Project: Engineering, Procurement and Construction of the New Administrative Capital Monorail and 6th October City Monorail (Contract 93/Metro).

Subject: Comments on shop drawings. // 93M-BOA-NAT-LOT-21635

93M-BOA-NAT-LOT-21635

DRAWING TITLE
6TH OF OCTOBER MONORAIL
SERVICE WALKWAY
ZONE (1016)
PLAN AT EL+0.200

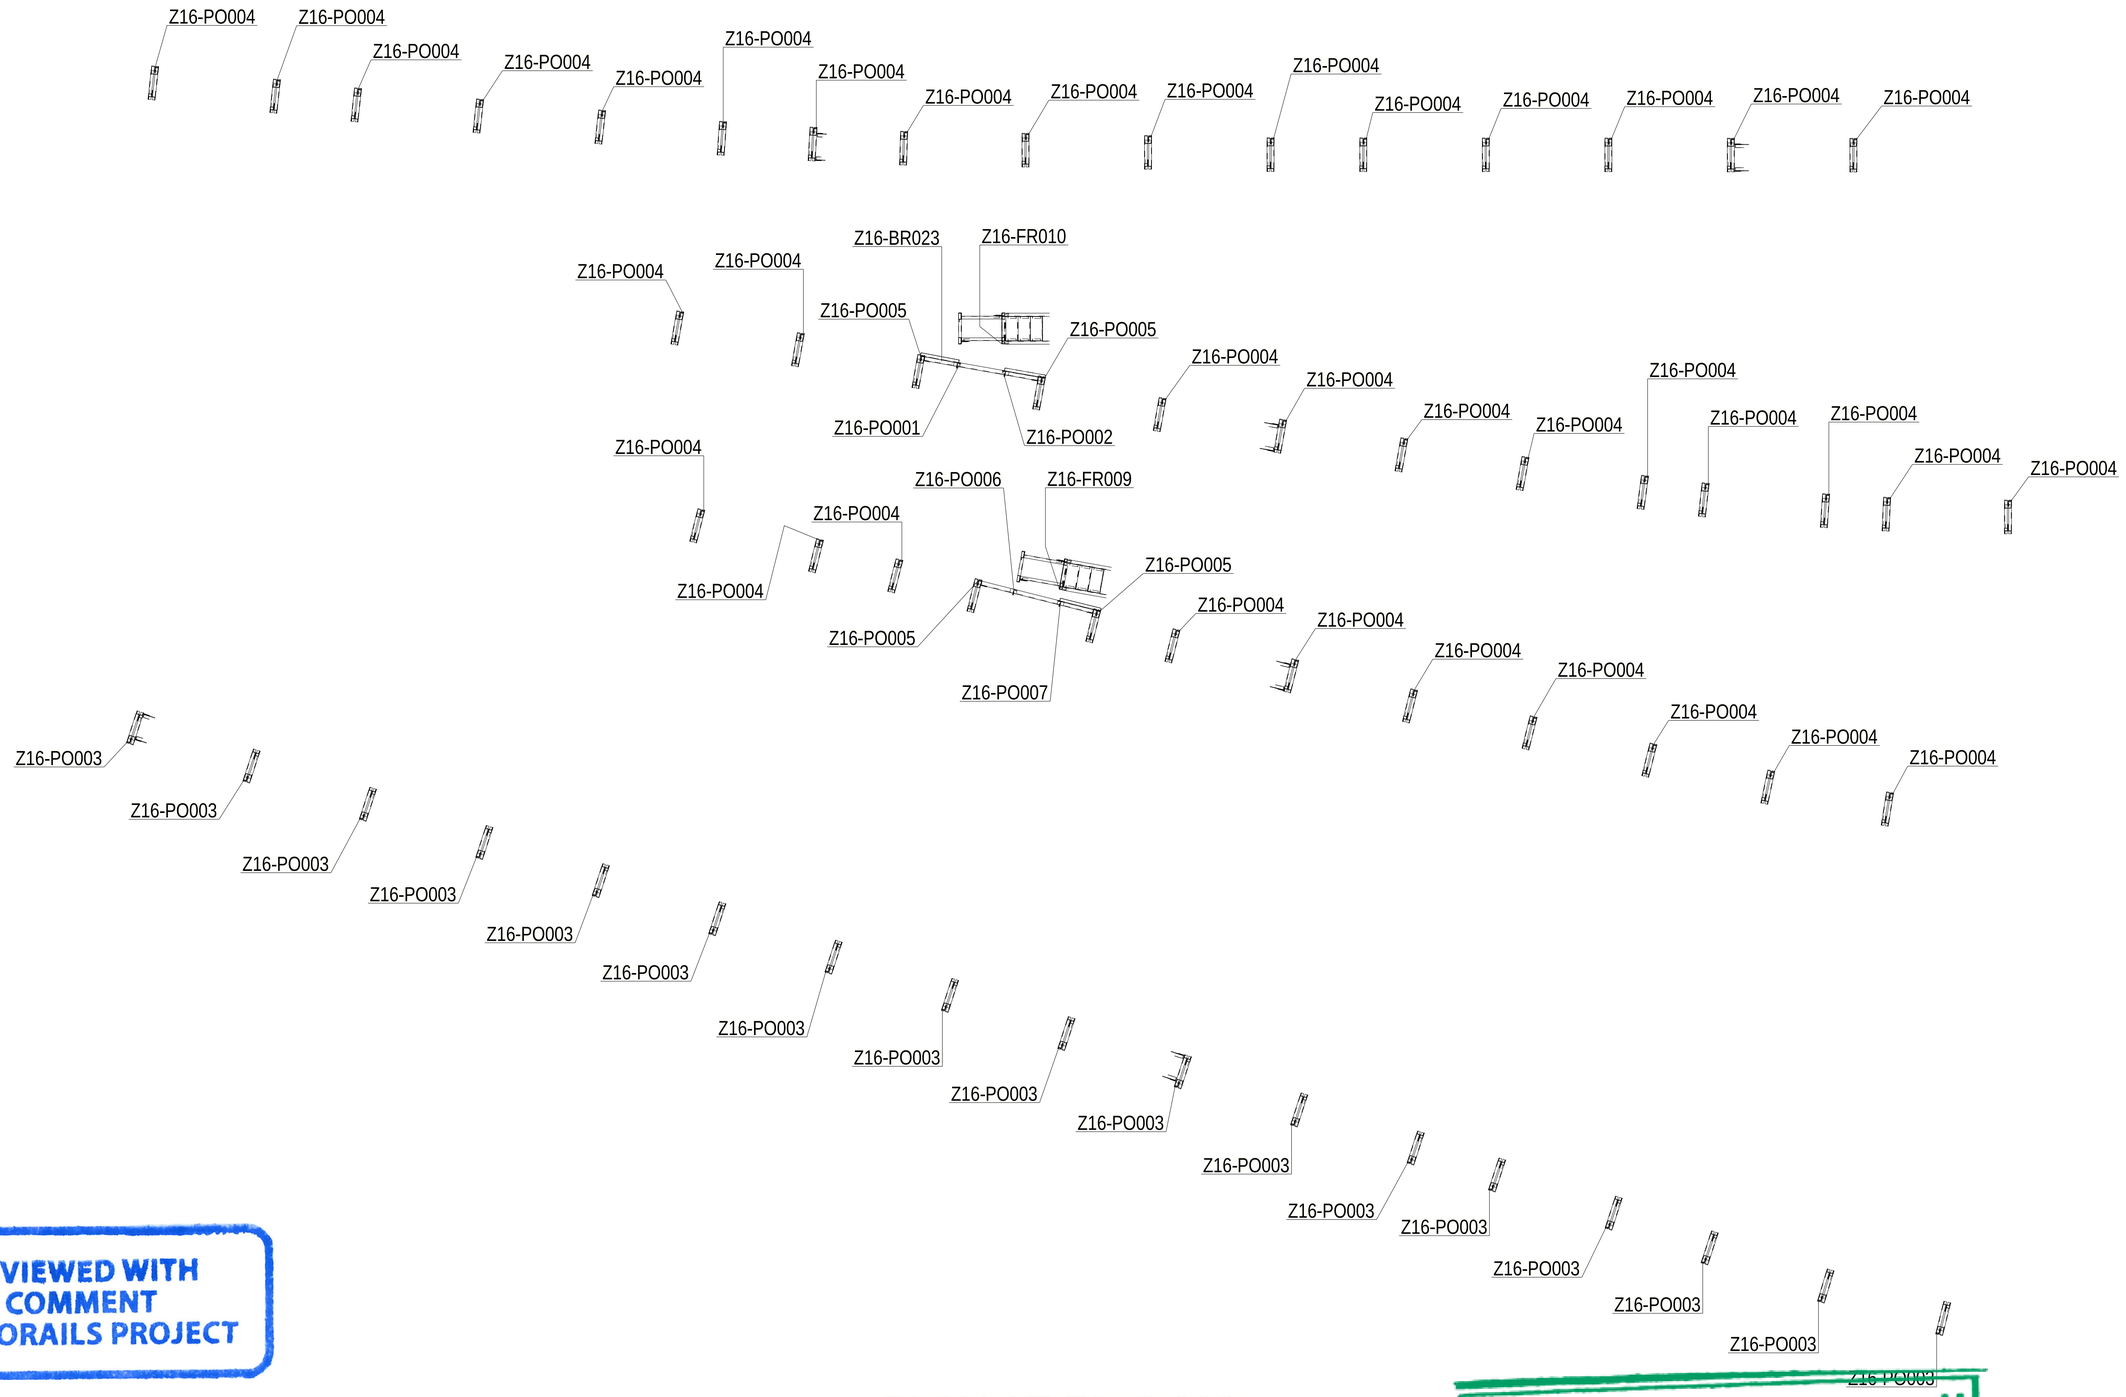
Approval is subject to approval of coordination package between multi-discipline.

DRAWING TITLE
6TH OF OCTOBER MONORAIL SERVICE WALKWAY
ZONE (1016)
HANDRAIL PLAN

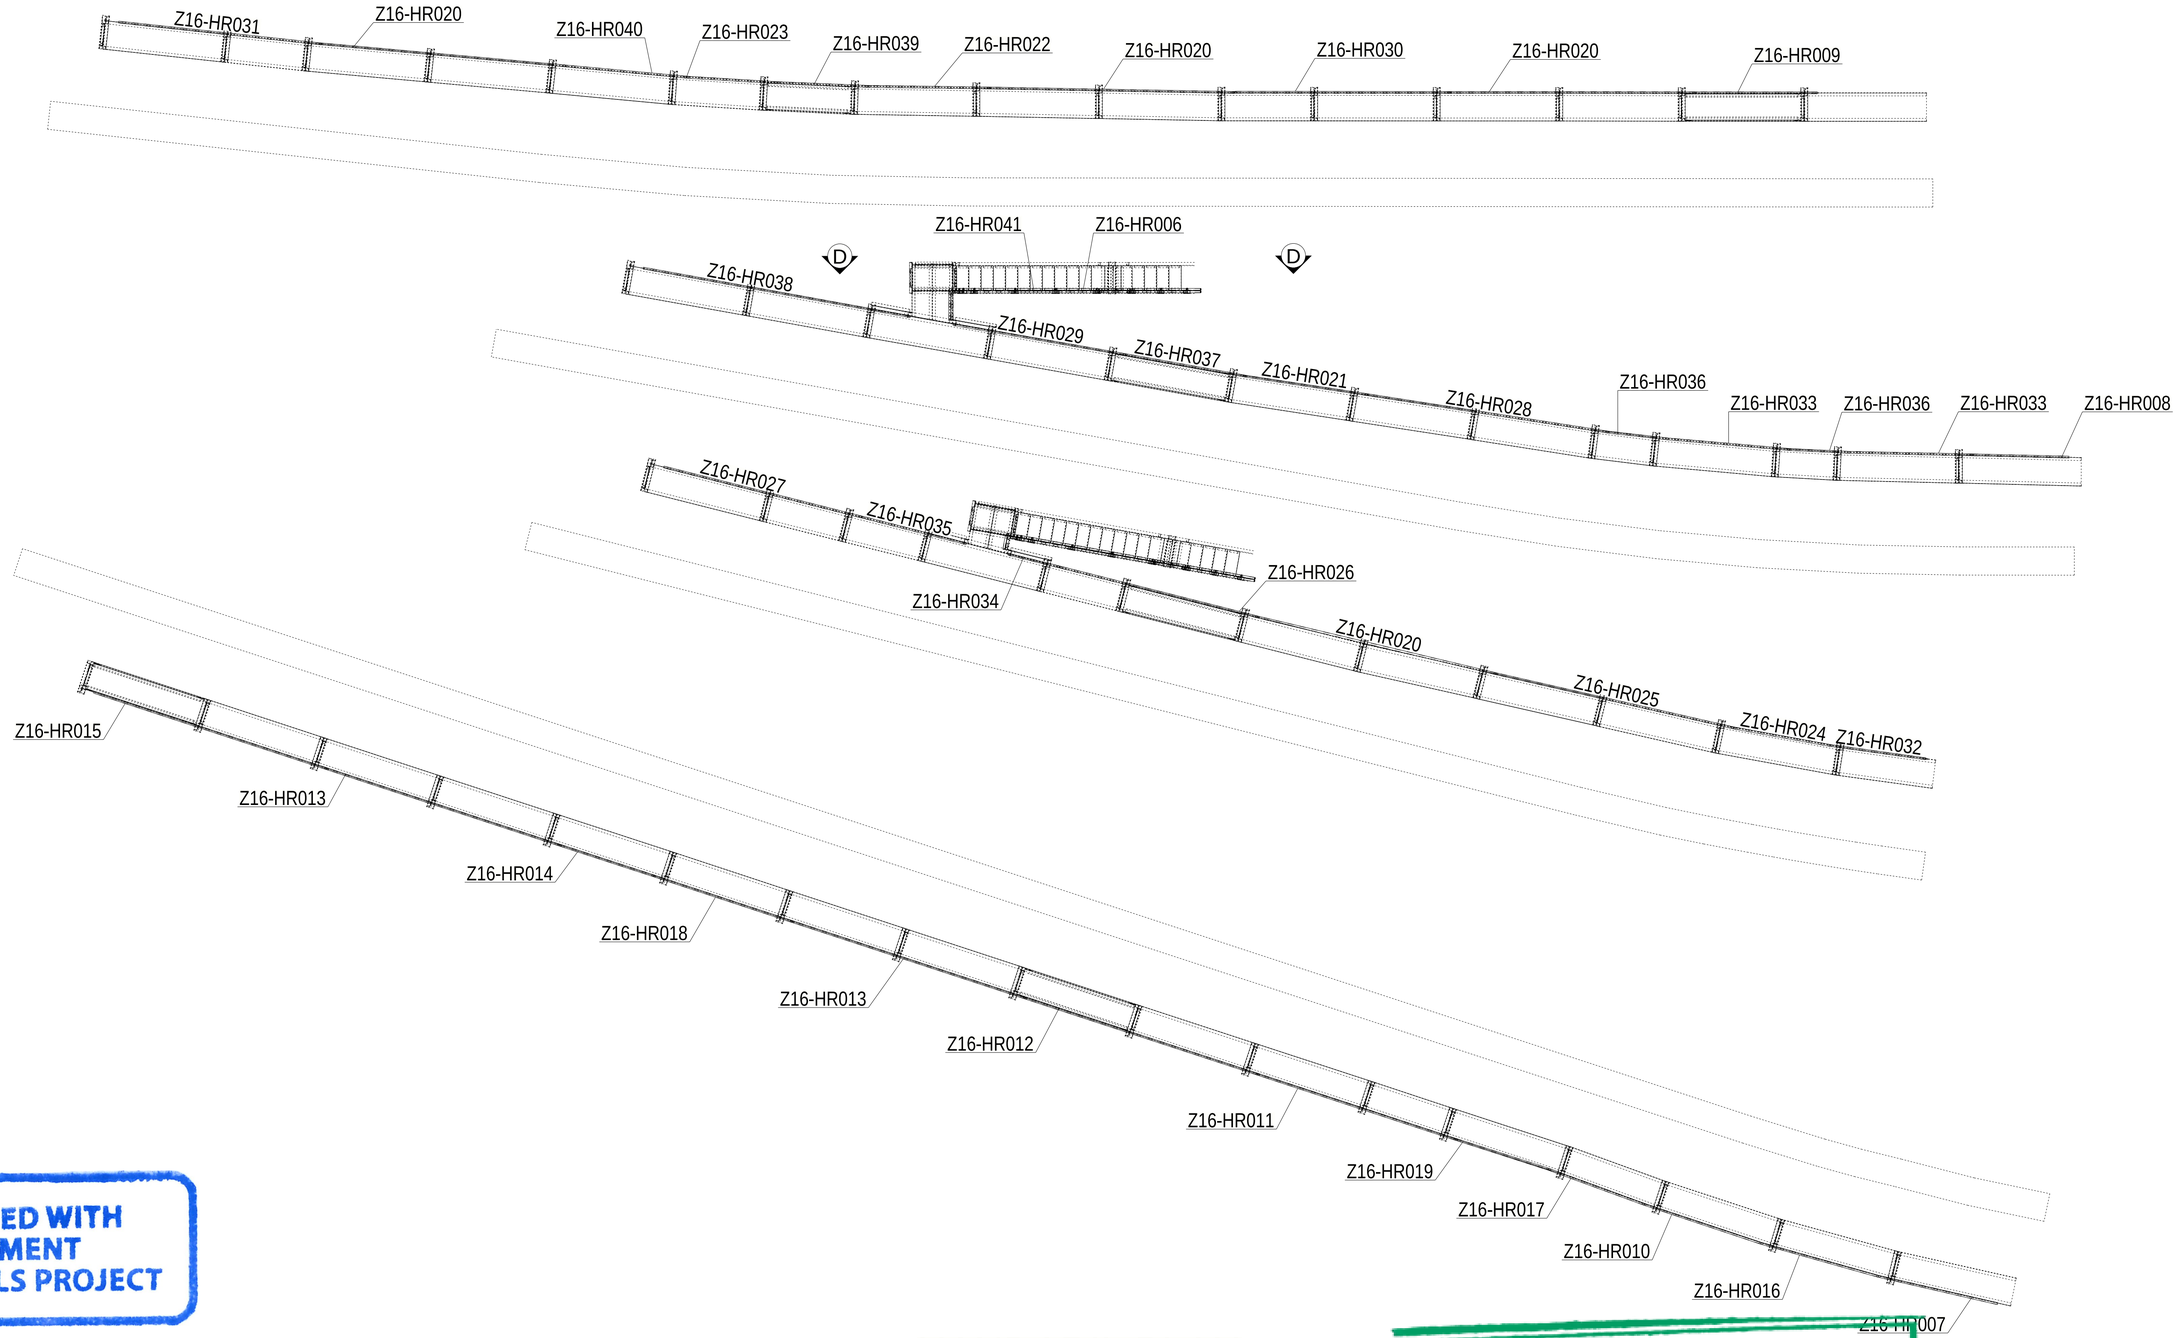
Approval is subject to approval of coordination package between multi-discipline.

DRAWING TITLE
6TH OF OCTOBER MONORAIL
SERVICE WALKWAYS
ZONE(1016)
Z16-CHQ005

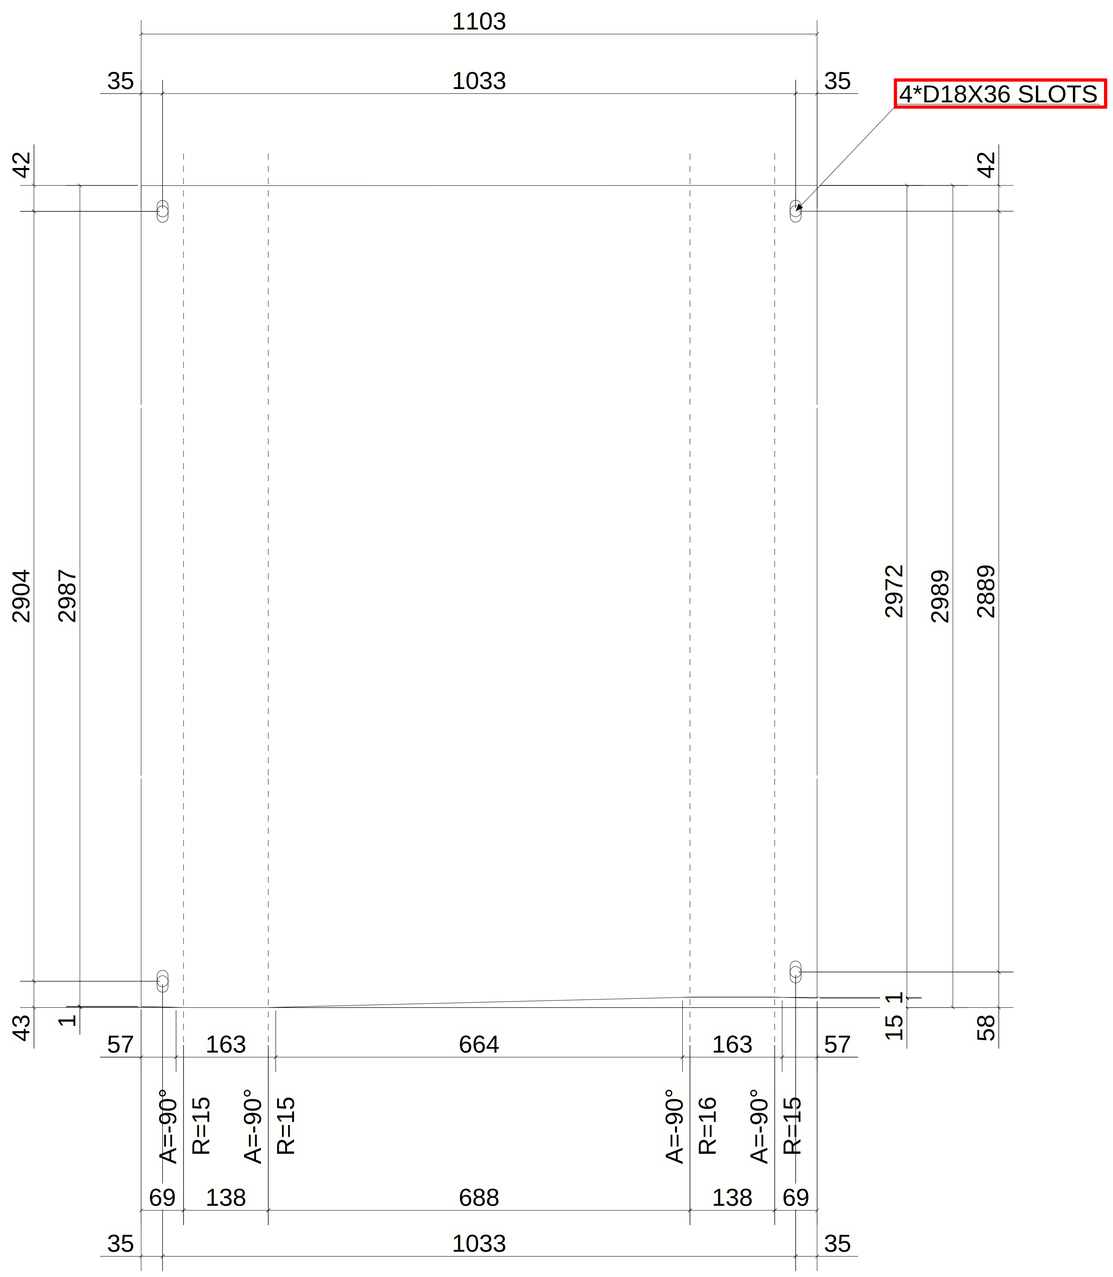
The slot should be short slot a shown in the design reference which is (18*22) according to ANSI/AISC 360-05.

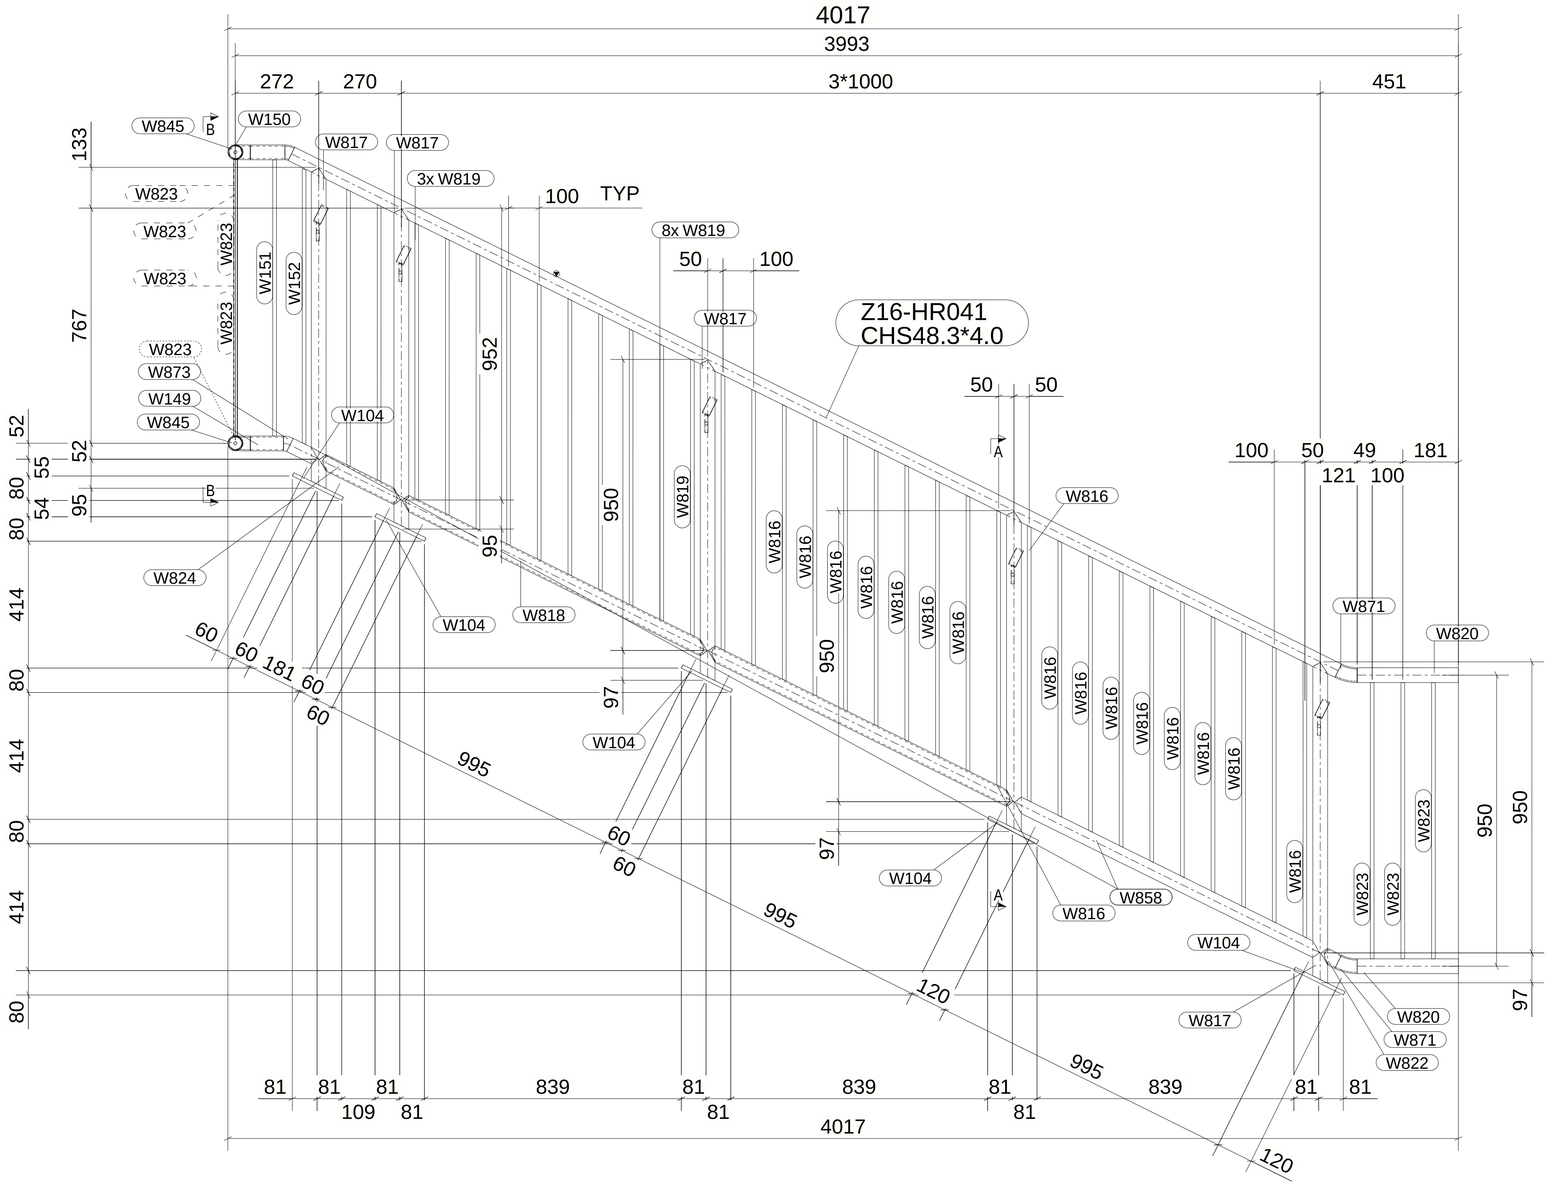
Approval is subject to approval of coordination package between multi-discipline.
